CITY OF PORTLAND, MAINE

HISTORIC PRESERVATION BOARD

HISTORIC PRESERVATION BOARD MEETING

WORKSHOP
10 EXCHANGE STREET

A2.01

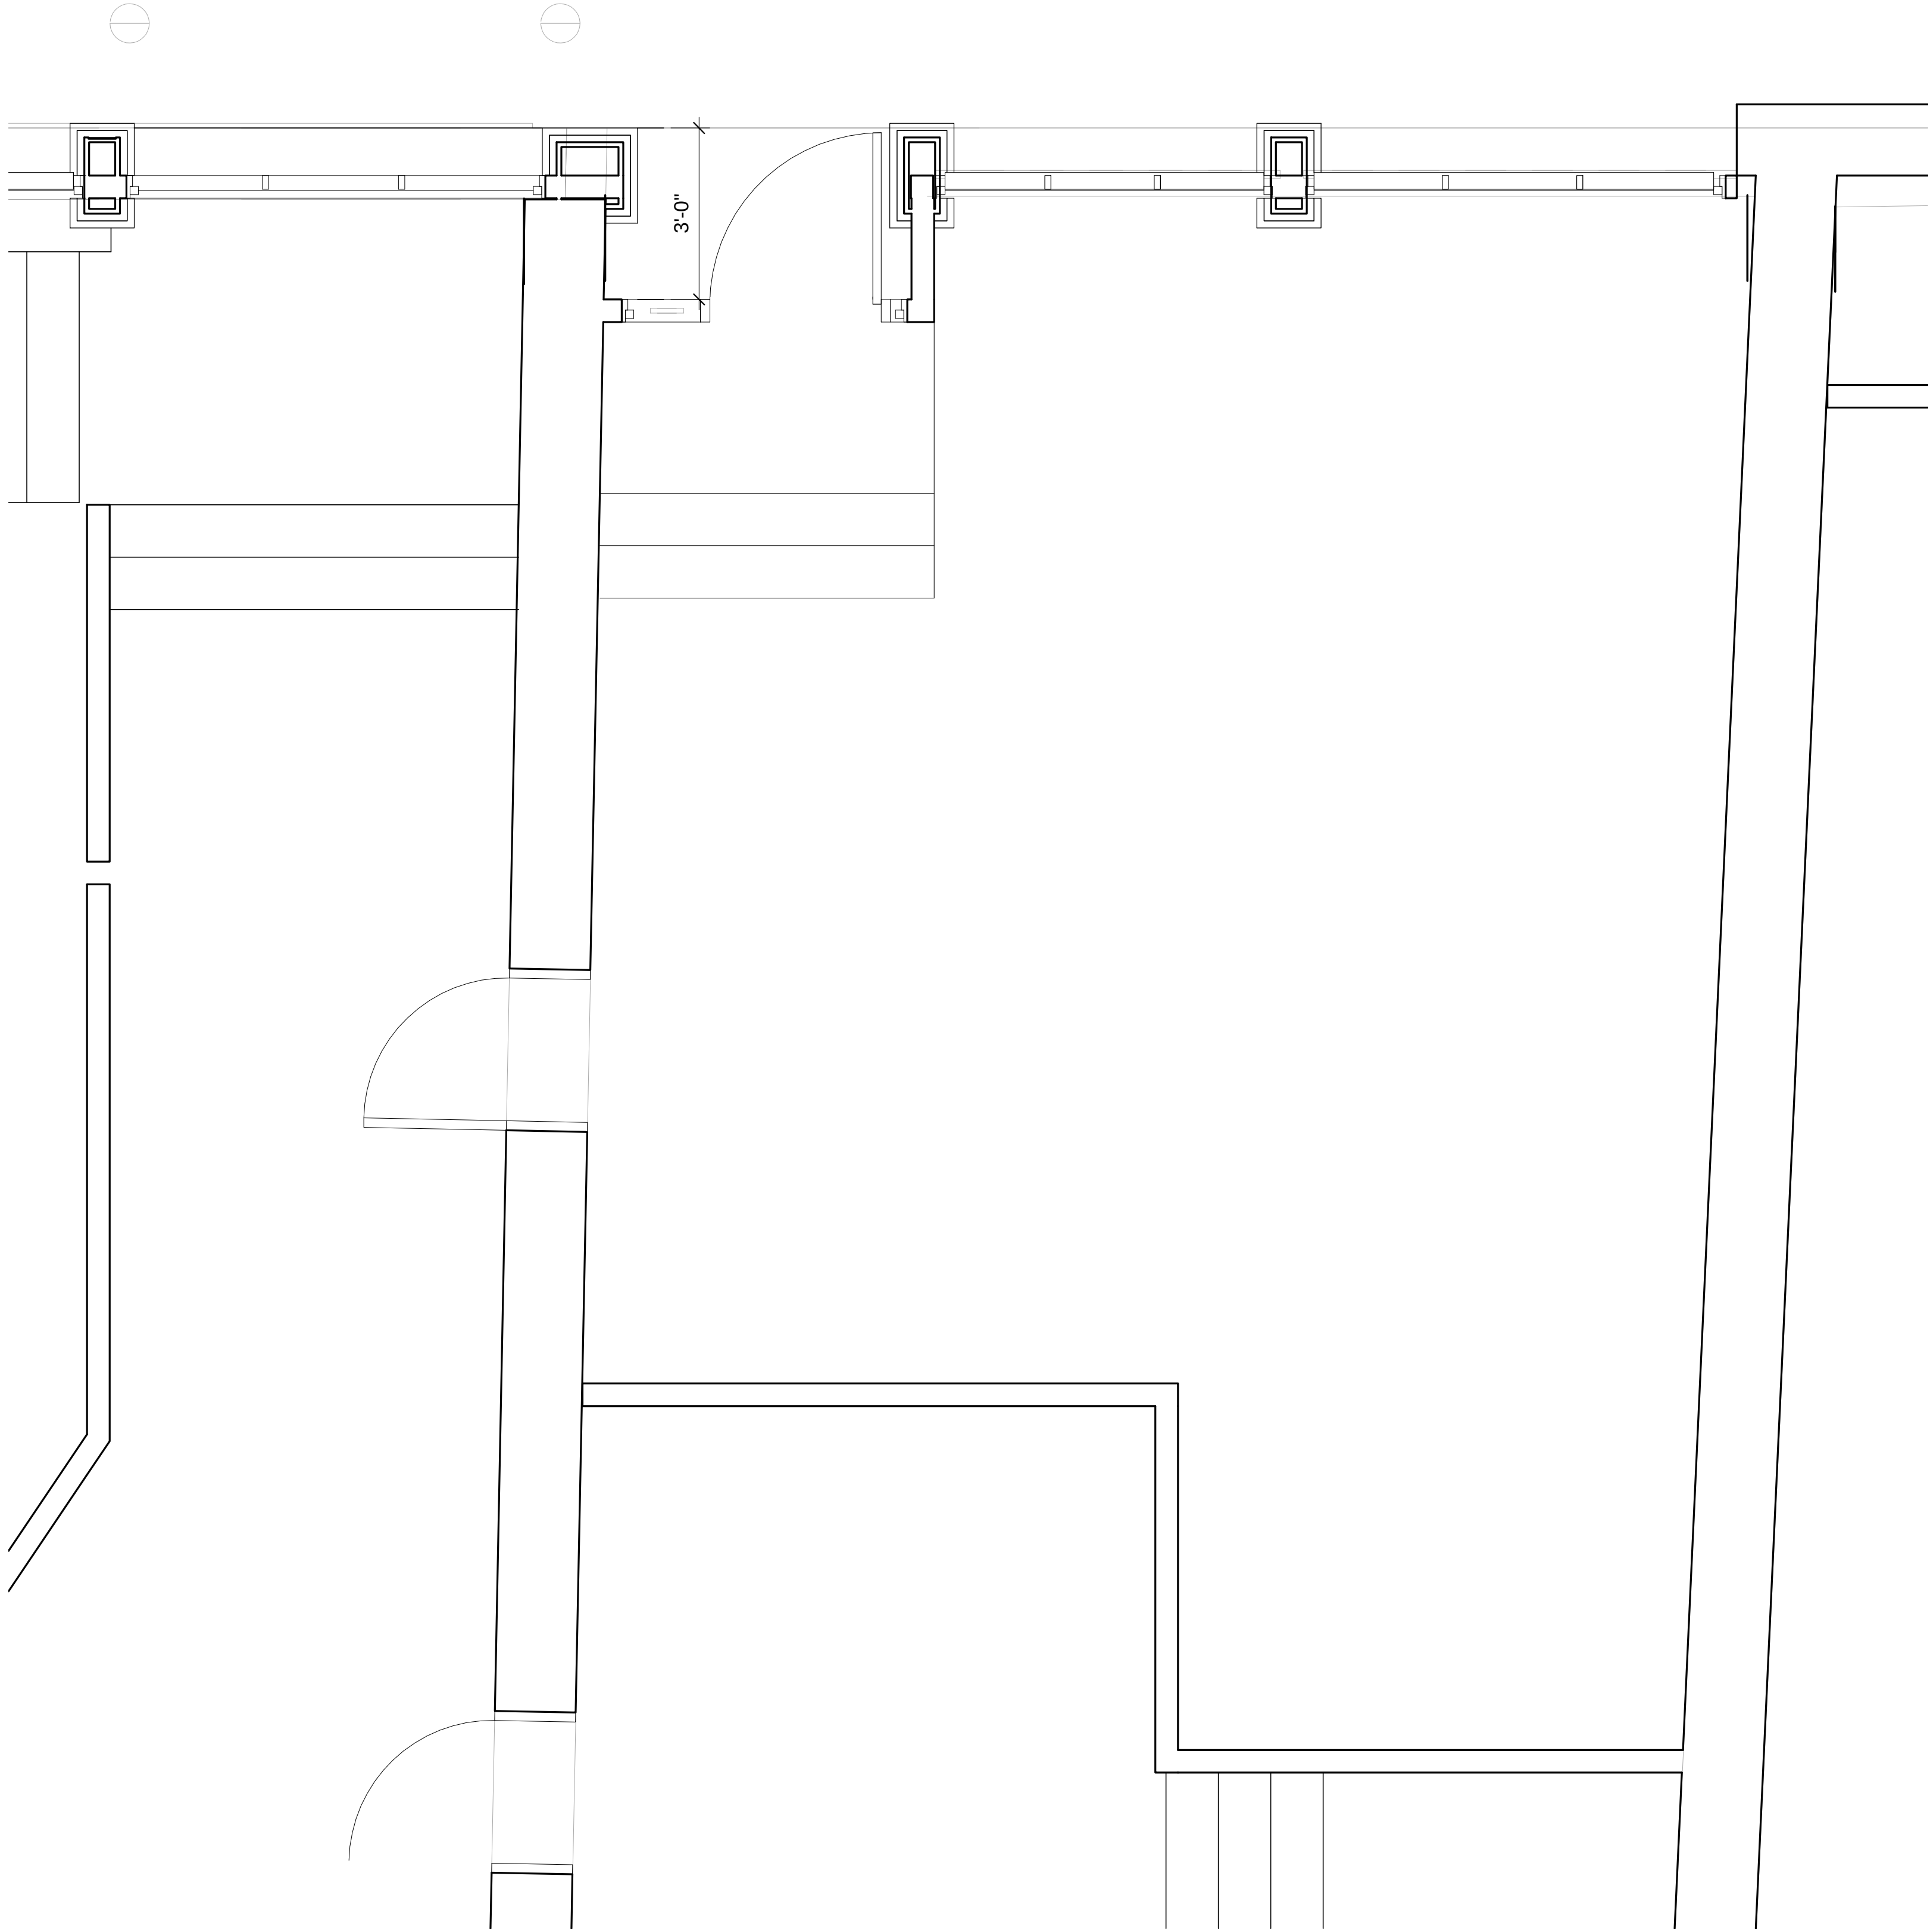
While staff understands the motivation for providing a direct entrance to the store from the sidewalk, the proposed changes deserve careful consideration. The existing storefront at the subject property retains a consistent historic character, whether or not it is actually all original material. Several of the Standards for Review of Alterations have relevance to the review of the proposed storefront changes – particularly Standard 2's injunction against "removal or alteration of any historic material or distinctive architectural features ... when possible." (Please see the Applicable Standards, below.)

That said, as noted above, the photographic evidence suggests that at least some if not all of the units in the large block may have originally had recessed entrances to the centers of the individual retail spaces. With the grade change on Exchange Street and the clear steps up from unit to unit – and what it implies for original interior floor levels - this makes some sense given what we know about historic commercial buildings. It is difficult to say whether interior spaces in the third and fourth units were aggregated long ago into a larger space, or were used as smaller units with one centralized entrance instead of individual entrances. It is also unclear how and where access was originally provided to upper floors.

Staff believes that if a new entrance is to be considered it should be in the center of the three bays of the storefront, and must be handled with sensitivity – which seems to be the intent of the architect. The proposed location in the right hand bay is immediately next to the large entrance with its double doors – an unfortunately imbalanced juxtaposition. A clear separation of the individual retail entrance from the primary entrance to upper floors would be logical. Finally, though it would be wise to be wary of basing alterations entirely on conjecture; and wary of creating a false sense of history, there may be enough evidence here and in other storefronts to justify a sensitively designed alteration.
